SUBJECT: ENGINE TURBOCHARGER OIL PRESSURE INLET CHECK VALVE, TELEDYNE CONTINENTAL MOTORS (TCM) P/N 642211

MODELS/SERIAL NUMBERS AFFECTED: Model M20K - S/N 25-0001 thru 25-0447

FIGURE 1

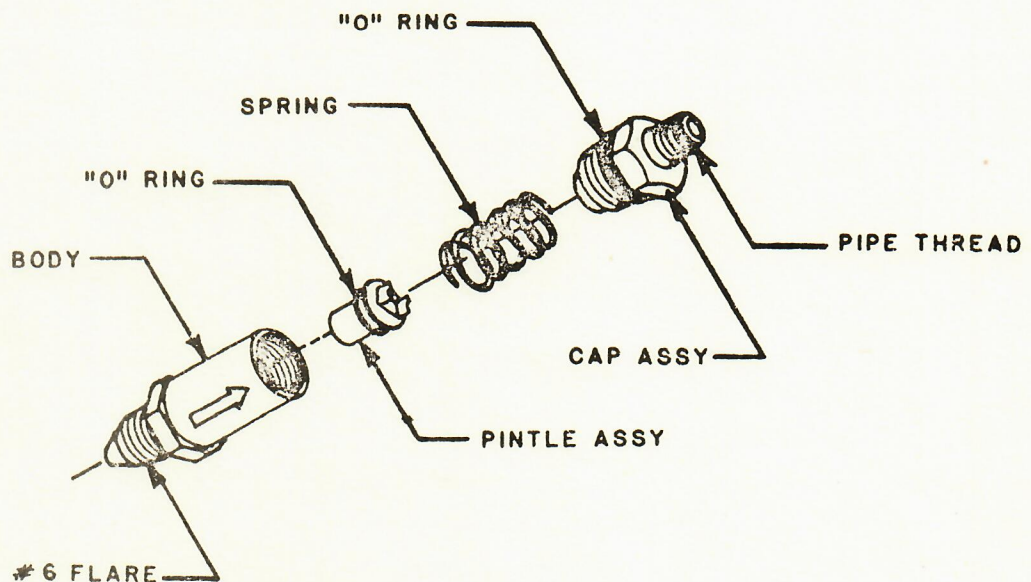
INTRODUCTION: It has been determined that in some instances during installation of the subject check valve the recommended torque values may have been exceeded. Replacement of the pipe thread end of check valve is required per this Service Bulletin. This S.B. is to be done in conjunction with TCM S.B. M80-19. Warranty claims to be filed with TCM distributor for **all parts** and one (1) **hour labor** allowance to accomplish **both bulletins**.

3. Place check valve, P/N 642211, in vise or clamping device. Clamp the hex portion at the flare fitting end with arrow on check valve pointing straight up.

4. Remove the pipe thread fitting end cap assy by turning hex portion on that end of valve with wrench.
5. Install new cap end and "O" ring assy, TCM P/N 643825, after coating threads of cap body with engine oil. Torque to body of check valve with 55-60 inch lbs. The new cap end will be blue color for identification.

6. Reinstall complete check valve assy to the 45° fitting on turbocharger after coating pipe thread end with engine oil. Torque unit 60-80 inch lbs. into the 45° fitting. Be careful to prevent any bending or torsional loads to the pipe thread end.

7. Attach the hose and tighten while holding the check valve with wrench to prevent bending or torsional loads being transmitted to the pipe thread end. Torque this flare nut 75 to 125 inch lbs.
